UPDATE TO THE NRS FRAME ANCHOR SYSTEM WITH 2:1

The following update is only intended for the NRS Frame Anchor System with 2:1 (93081.03.100 and 94909.02.100). All other anchor systems, including those found on Slipstream Rafts, are NOT affected.

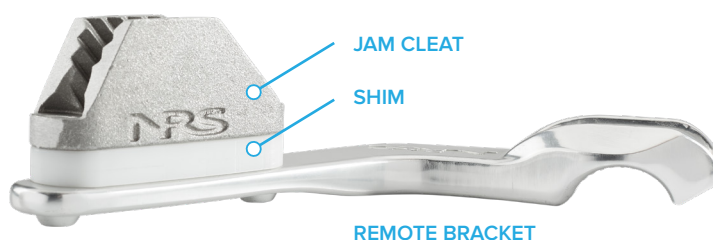
NRS has discovered that the new version of the NRS Frame Anchor System has an improperly aligned jam cleat and pulley, causing the rope to pull up and out of the cleat when weight is applied to the anchor.

To fix this problem, NRS created a shim/spacer to add space between the jam cleat and remote bracket. By adding the shim, it realigns the jam cleat and pulley and allows for more “bite” on the anchor rope.

1. Note the orientation of the cleat compared to the pulley, then use a #3 Philips head screwdriver to remove the current jam cleat. These screws can be very tight; the use of an impact driver may be helpful.
2. Discard original screws. Install the shim between remote bracket and jam cleat using the screws supplied with the shim. Make sure the jam cleat is oriented the correct direction. Fully tighten screws.
